Hammarlund Manufacturing Company

SERVICE BULLETIN

Dear HX-500 Owner:

Bulletin No. 5001-1

5. AUDIO DISTORTION *check*

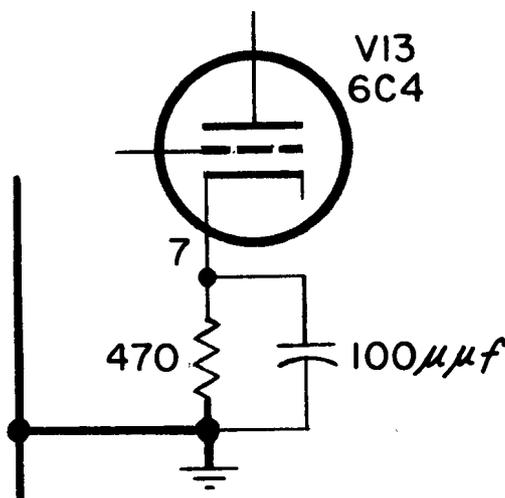
As a result of employing the mike input connector for phone patch operation or utilizing relatively high level output high impedance microphones, (such as D104 or similar) audio distortion of the transmitted signal may occur. In order to increase the input signal handling capabilities of the first audio stage, the following modification should be made. 1) Lift the cathode pin #3 of V5A and 100 mmf capacitor C144 from ground. 2) Connect a 3900 ohm, 1/2 watt resistor from pin 3 of V5A to ground. 3) Connect C44 to a new ground point in the vicinity of the original ground. 4) Replace the 4.7 meg. R32 resistor with a 470K, 1/2 watt resistor. It is permissible to shunt R32 with this new resistor. 5) Depending upon your particular voice qualities and the mike employed, it may be desirable to replace the 1000 mmf coupling capacitor C45 with a .01 disc ceramic capacitor. This last change will improve low frequency response.

BOTTOM VIEW OF HX-500 CHASSIS

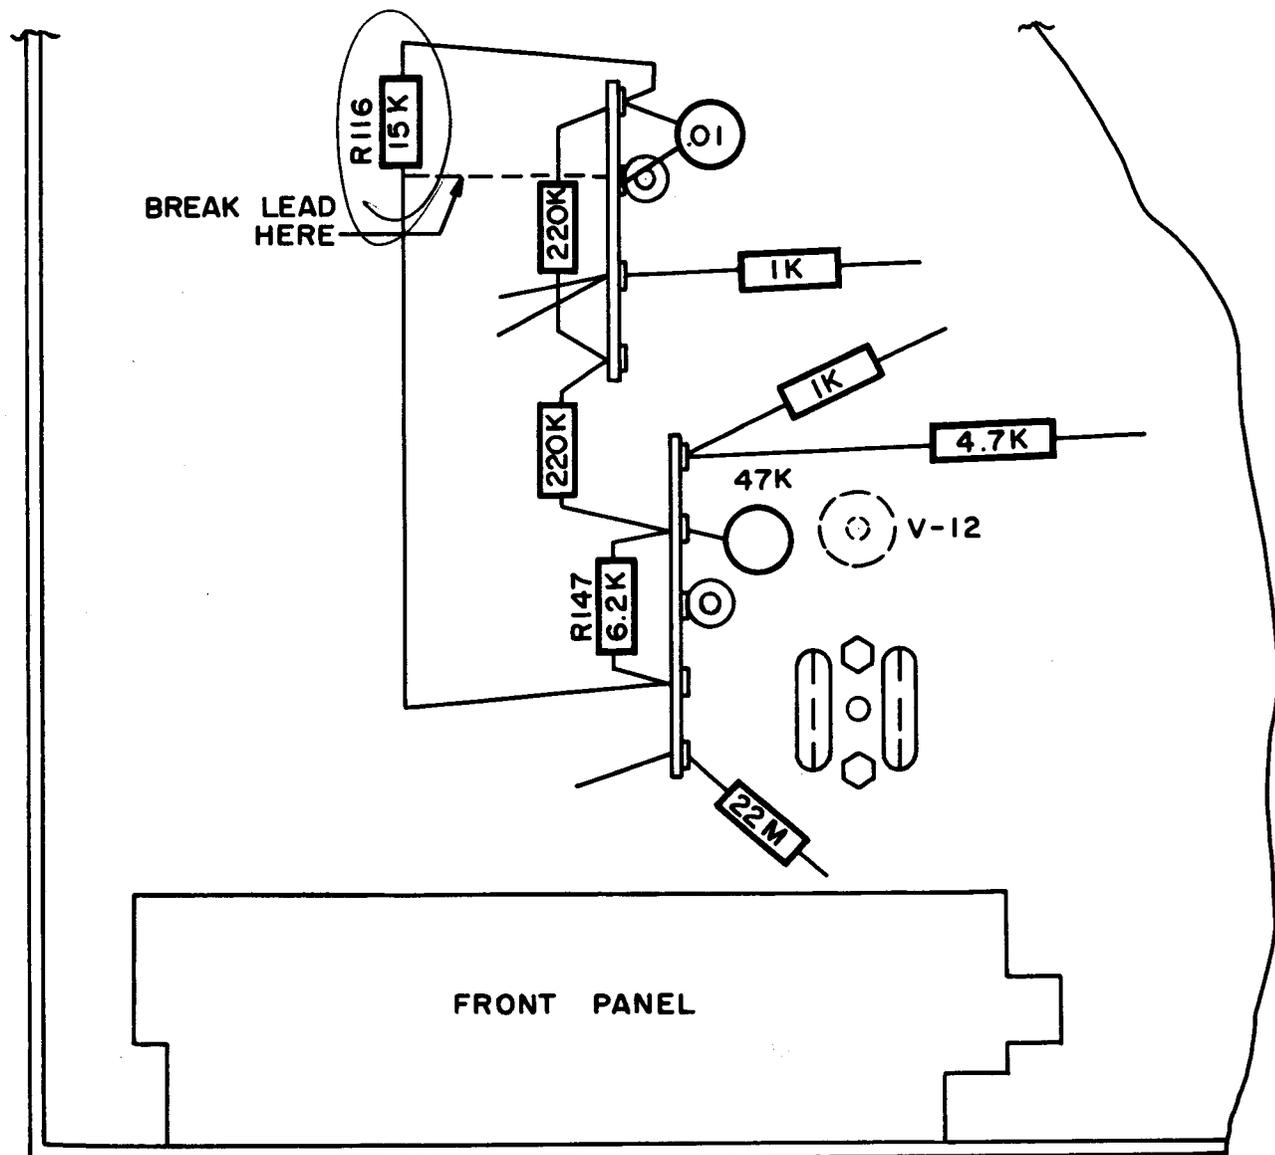
NOISE OR HASH ELIMINATION

Check 15K Resistor on sum strip

In order to minimize if not completely eliminate noise or hash which you may have noticed in your receiver, (particularly on the higher frequency bands) while the transmitter is on standby, we suggest the following remedy; 1) Lift the ground end of R116, the 15K resistor in the V14 driver grid circuit and connect to the bottom end of R147, the 6.2K resistor in the third mixer grid circuit. 2) The two terminal strips on which these resistors are mounted are located near to each other so that a new 15K resistor can be connected between these two terminal strips, or a short length of insulated wire connected to the now ungrounded end of R116 and to the proper tie point for the 6.2K, R147 resistor. 3) The diagram following indicates this circuit change and as a result of this modification, the driver stage will be biased to cut-off, effectively blocking any drive to the final when in standby.

NOTE: MAIN CHASSIS PARTS LIST CHANGE - RESISTOR R-132, 220 OHM TEN WATT RESISTOR, REPLACED WITH 15 OHM 2 WATT RESISTOR. FIELD USE INDICATES THAT THIS RESISTOR IS OPERATING TOO CLOSE TO ITS DISSIPATION RATING.

11. CW VOX OPERATION *All Sup #1*

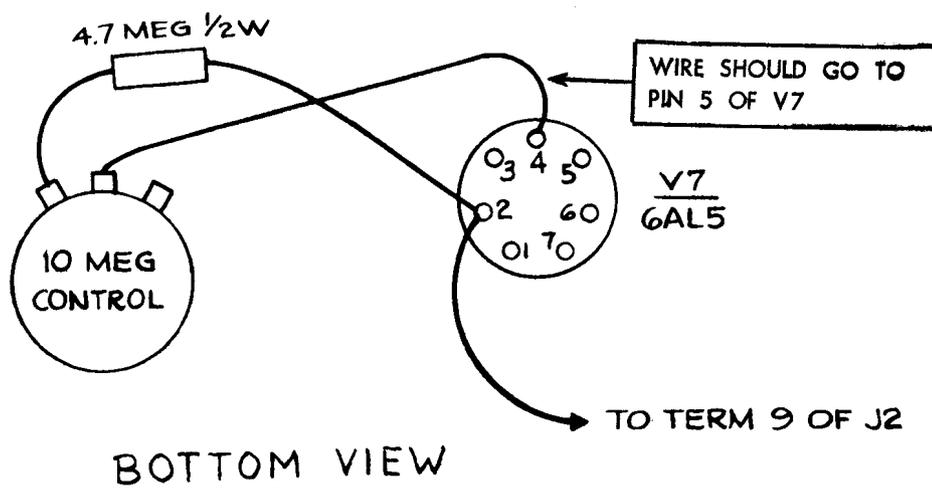
The use of the VOX circuitry to provide semi "break-in" operation may be achieved by a relatively simple modification. When this change is made and the function switch is in the CW position, with the operations switch in the MOX position, the first touch of the key will cause the transmitter and its associated relay circuitry to go from the standby mode to operate. The transmitter will stay in the operate mode for a period of time after the key is released, depending upon the time constant selection (adjustable). In normal operation the transmitter will remain in the operate position thereby muting the associated receiver during the course of a sending cycle. A short interval after the sending has ceased, the transmitter will automatically go back to standby and the receiver will become alive, thereby providing a form of "break-in" operation, which does not require the throwing of any switches, etc. To make this modification the following steps are required:

4. Connect a 4.7 megohm, 1/2 watt resistor from the terminal of the 10 megohm potentiometer as shown in the sketch below.

1. Install a 10 megohm linear taper potentiometer on the exciter assembly sub-chassis between V8 and T3/T4. It will be necessary to drill a 3/8" hole in the chassis to accept this part. (Obtain same from local dealer).

3. Wire the center connection (arm) of this control to Pin 5 of V7A.

5. Connect the other end of this 4.7 megohm resistor to Pin 2 of V7.

Add a lead from terminal 9 of the chassis connector J2 (keying circuitry) to terminal 2 of V7. NOTE: Refer to page 21 of the Instruction Manual for a top view photograph of the exciter assembly sub-chassis for major component location.

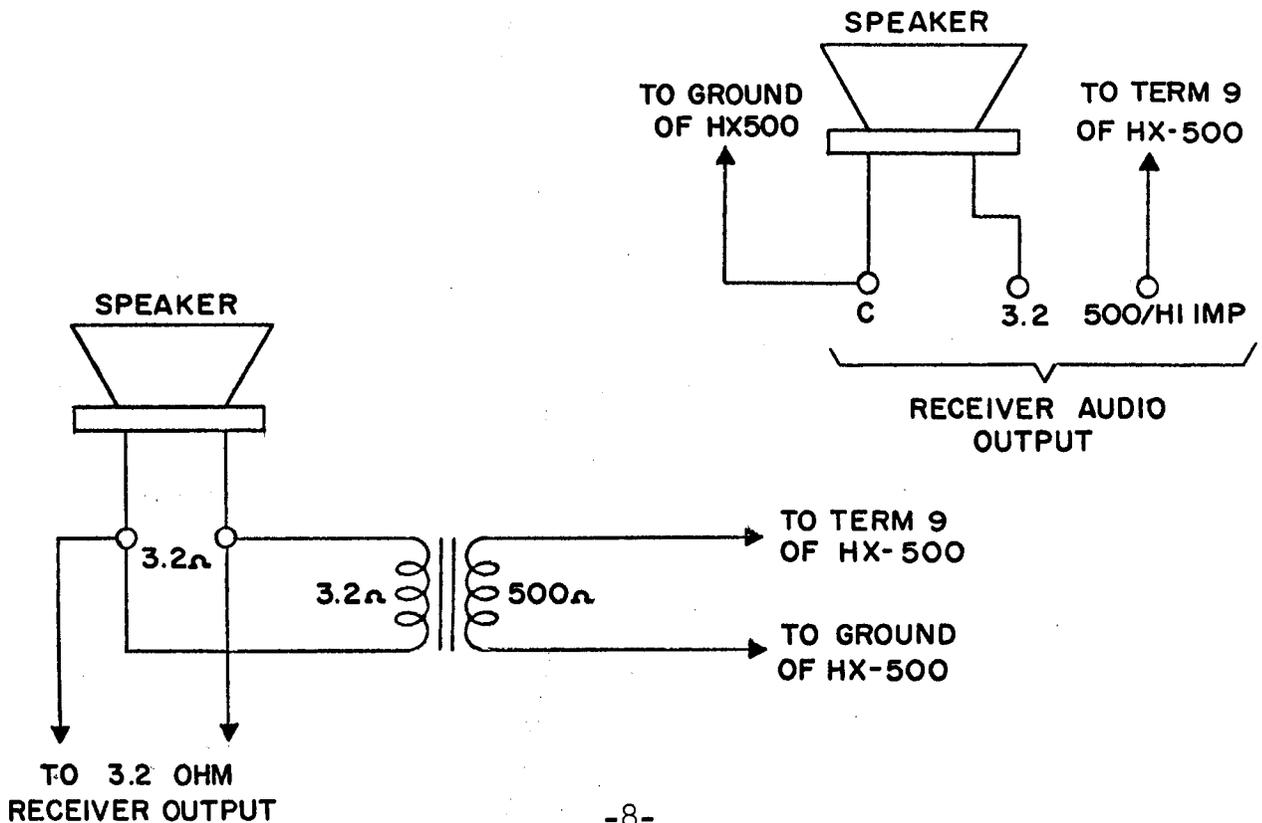
Under certain conditions (depending on microphone, speaker and room acoustics) insufficient anti trip action may be present. Additional anti trip gain may be achieved by increasing the value of R52 (screen circuit of V8A-6U8) to 820,000 ohm - 1/2 watt. If your receiver has a 500 ohm or high impedance audio output, same should be used to feed the anti trip signal to the receiver. In this instance the station speaker should be connected directly across the receiver output. A transformer may be employed as shown below in lieu of a high impedance receiver audio output.

EXCITER CHASSIS FRONTBOTTOM VIEW

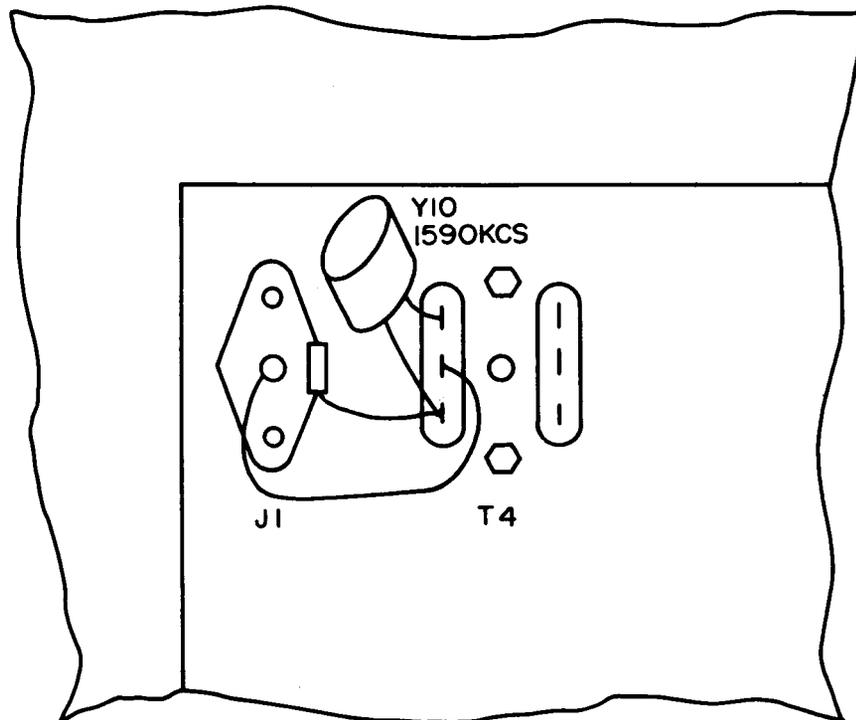
Although this spurious response is down in excess of 50 db, under certain conditions additional attenuation may be desirable. Approximately 20 db of additional attenuation may be achieved by the use of a 1590KC trap crystal, Hammarlund part no. K42345-1 should be installed as follows; 1) Assuming that the unit has been removed from the cabinet, remove the bottom cover of the exciter chassis. 2) Clip the pigtail leads of the new crystal leaving approximately 1/2" in length. Solder the crystal across the bottom winding of T4. The crystal should be soldered to the lugs either side of center as indicated in the diagram below:

The installation of this crystal will not affect the setting of the present 1590KC trap. However, it is advisable to re-check this trap for maximum suck-out in accordance with the appropriate section of the Instruction Book.
